Model: RT46 for Bellini-C2		Date: 20-May-03	No.: MB511001
Modified Article: Reverse Pressure Spring - 55GF		Prepared by: F.Noguchi	
From: 2nd Tech. Support Sec. Service Support Dept.			
Reason for Modification:	<input type="checkbox"/> Parts catalog correction <input type="checkbox"/> To facilitate assembly <input type="checkbox"/> Part standardization	<input type="checkbox"/> Vendor change <input checked="" type="checkbox"/> To improve reliability <input type="checkbox"/> Other	<input type="checkbox"/> To meet standards ()

Model: Bellini LCT		Date: 8-Nov-06	No.: MB511002
Modified Article: MAGNET CATCH		Prepared by: S. Ishizu	
From: 2nd Tech. Support Sec. Service Support Dept.			
Reason for Modification:	<input type="checkbox"/> Parts catalog correction <input type="checkbox"/> To facilitate assembly <input type="checkbox"/> Part standardization	<input type="checkbox"/> Vendor change <input type="checkbox"/> To improve reliability <input type="checkbox"/> Product Safety	<input type="checkbox"/> Other <input checked="" type="checkbox"/> To meet standards ()

Model: Bellini-C2 LCT(RT46)		Date: 6-Dec-06	No.: MB511003
Modified Article: Link Guide Plate – Open And Close		Prepared by: S

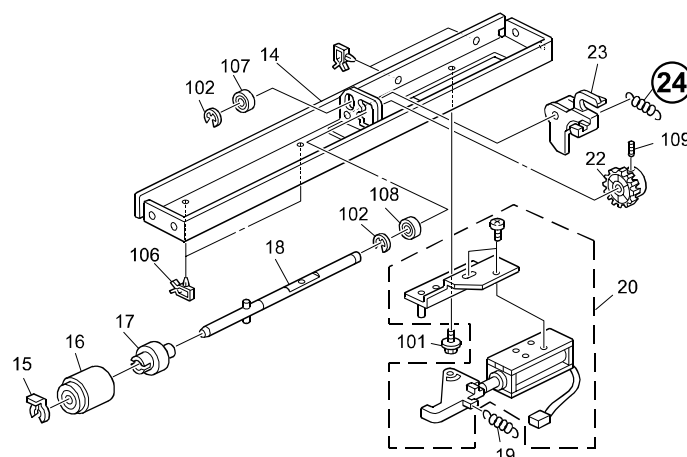
The Reverse Pressure Spring has been changed as follows to improve paper feed performance.

- Pressure increased
- Diameter increased (0.45mm→ 0.5mm)
- Pre-attachment length increased (18.0mm→ 21.4mm).

Old part number	New part number	Description	Q'ty	Int	Page	Index	Note
AA060834	AA060941	Reverse Pressure Spring - 55GF	1 - 1	X/O	19	24	
		Spring: Pressure: Reverse

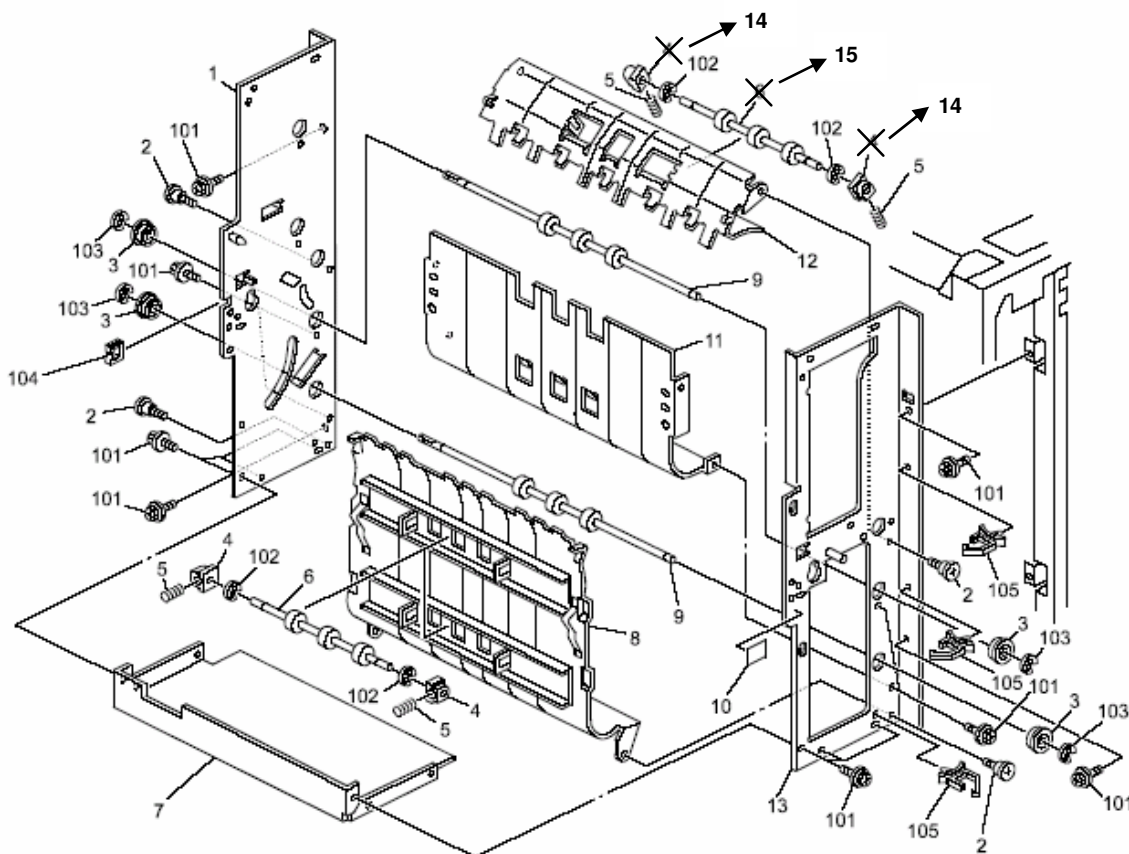
Old part number	New part number	Description	Old Q'ty	New Q'ty	Int	Page	Index	Note
B5113646	B5113621	Link Guide Plate – Open And Close	1	1	O/O	25	12	**
AA063852	AA066675	Pressure Spring	6	6	O/O	25	5	**
AA080034	AA080034	Bushing – 4x5x7	6	4	-	25	4	
	AA084059	Bushing	-	2	O/O	25	14*	**
AF020489	AF020489	Transport Relay Roller	3	2	-	25	6	
	B8342568	Transport Relay Roller	-	1	O/O	25	15*	**

Reason/Change: Parts standardization with ALASKA-C.

Important: If you need to install any of the new parts labeled “**” for the first time, install them **together as a set**.
